LOP - RECORD CHANGE REQUEST FORM

SITE NAME: Dreyers Grand Ice Cream DATE REPORTED: 01/11/1990 ADDRESS: 5929 -0 College Ave DATE CONFIRMED: 01/11/1990

Continuing Environmental Investigations

Dreyer's Grand Ice Cream

Proposed Geoprobe Locations at Dreyer's facility, Oakland

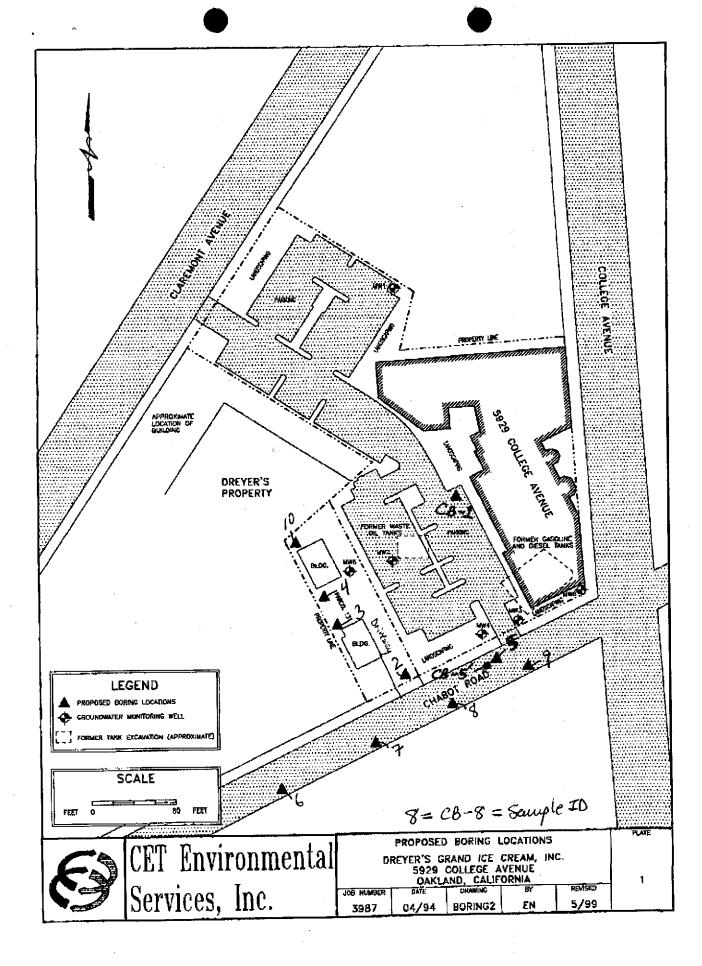
Per our meeting and subsequent telephone conversation yesterday, attached is a plan showing the proposed Geoprobe locations for the first phase of the investigation at Dreyer's. As we agreed, we will collect and analyze groundwater samples from these locations.

Before writing the letter to approve the workplan, I will wait to obtain a revised site plan showing revised hydropunch boring locations. Grover Buhr stated that he will fax me this figure tomorrow, Thursday (May 27, 1999).

RESPONSE TO CET'S MAY 3, 1999 MONITORING REPORT AND WORKPLAN

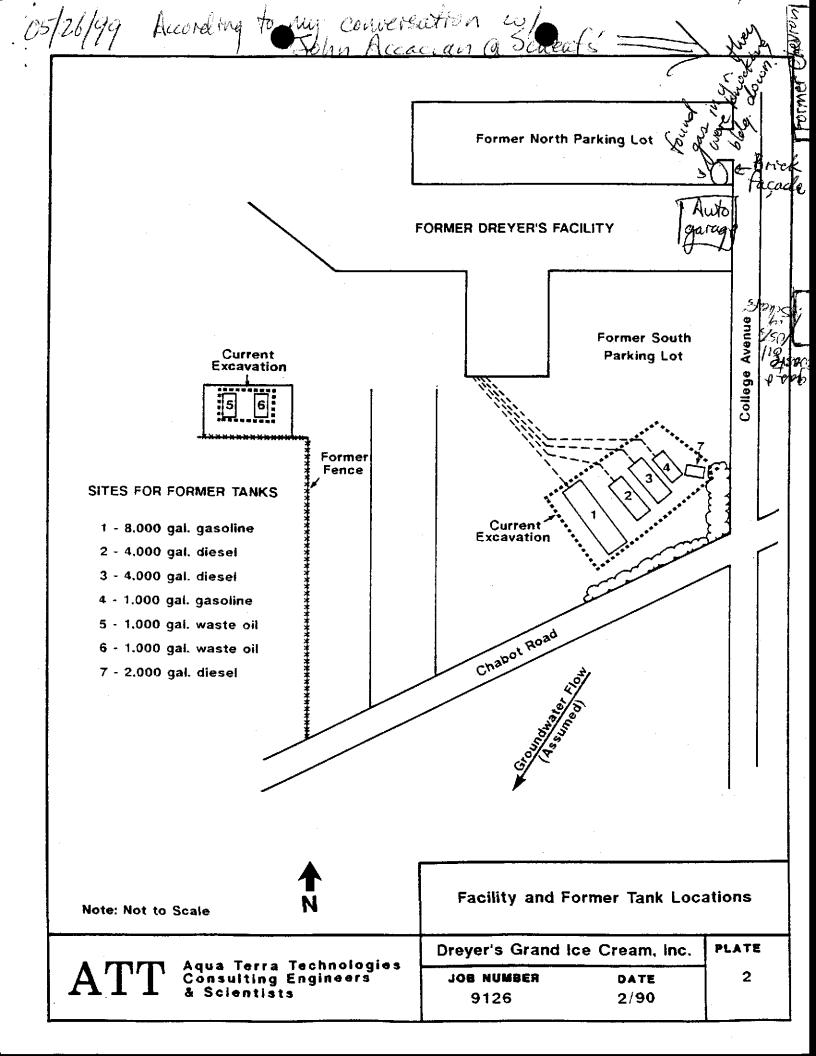
- Per my January 19, 1999 letter to your office, I asked that an 8260 analysis be conducted on Wells MW-2 and MW-5 in this last sampling event. However, you accidentally conducted the 8260 analysis on Well MW-3 instead of Well MW-5. The next round of sampling will need to include the 8260 analysis for MW-5 using low detection limits that are no higher than 50ppb for MTBE, TBA, ETBE, and TAME; and no higher than 100ppb for DIPE. No 8260 analysis will be required for MW-2 since no oxygenates were detected from this well.
